# UNITED STATES PATENT AND TRADEMARK OFFICE

APPLICATION NO.	FILING DATE	FIRST NAMED INVENTOR	ATTORNEY DOCKET NO.	CONFIRMATION NO.
10/689,287	10/20/2003	James R. McDonald	MCDZ 2 00001	3155
7590	01/19/2005		EXAMINER	
Scott A. McCollister Fay, Sharpe, Fagan, Minnich & McKee, LLP Seventh Floor 1100 Superior Avenue Cleveland, OH 44114-2518			BLAU, STEPHEN LUTHER	
			ART UNIT	PAPER NUMBER
			3711	
DATE MAILED: 01/19/2005

<b>Office Action Summary</b>	<b>Application No.</b>	<b>Applicant(s)</b>	
	10/689,287	MCDONALD, JAMES R.	
	Examiner Stephen L. Blau	Art Unit 3711

Enclosure (1)

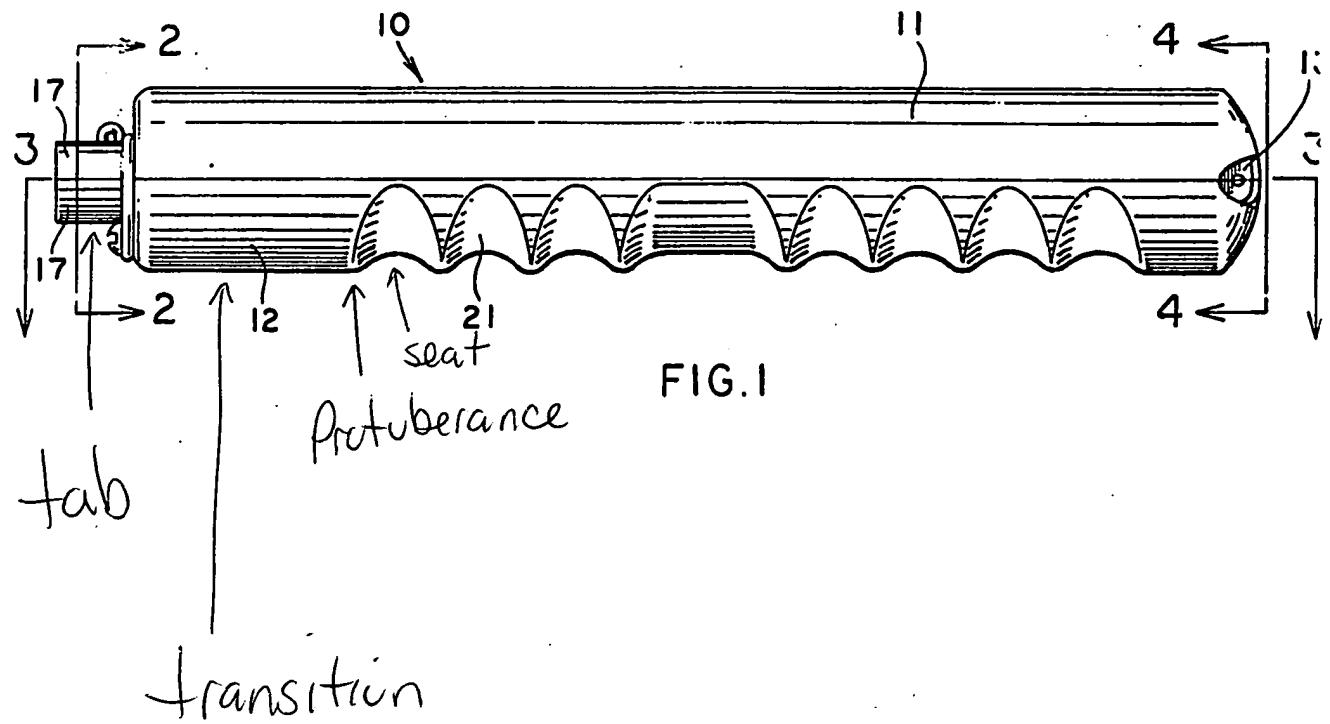
No. 17) extending from a least one of the first portion and the second portion, a second portion defining an opening in the form of the opening for the shaft (Fig. 2), a tab including a concave surface in the form of the inside surface of the tab (Fig. 5, Ref. No. 17), an attachment mechanism (Ref. Nos. 19-20) to selectively attach a first portion to a second portion (Fig. 2), an attachment mechanism including components (Ref. Nos. 19-20) attached to the tab (Figs. 1-2), an indicator in the form of the edges of the first and second portions along the entire length of the apparatus including adjacent the tab (Fig. 1) able to indicate if the apparatus is completely closed over a club, a tab having a surface able to receive a golfer's thumb (Fig. 1) and a seat (21) able to receive at least one of golfer's fingers, a tab being disposed 180 degrees from a seat in the form of the tab being on the upper body (Ref. No. 11) and the seat being on the lower body (Ref. No. 12) (Fig. 1), a protuberance extending from a body in the form of the rise between the seats (Fig. 1, Ref. No. 21), a protuberance between seats adjacent an opening in the form of when the body portions are separated the protuberances will be next to the edge of the opening (Fig. 1), and a protuberance transitioning into a tab (See enclosure (1)).
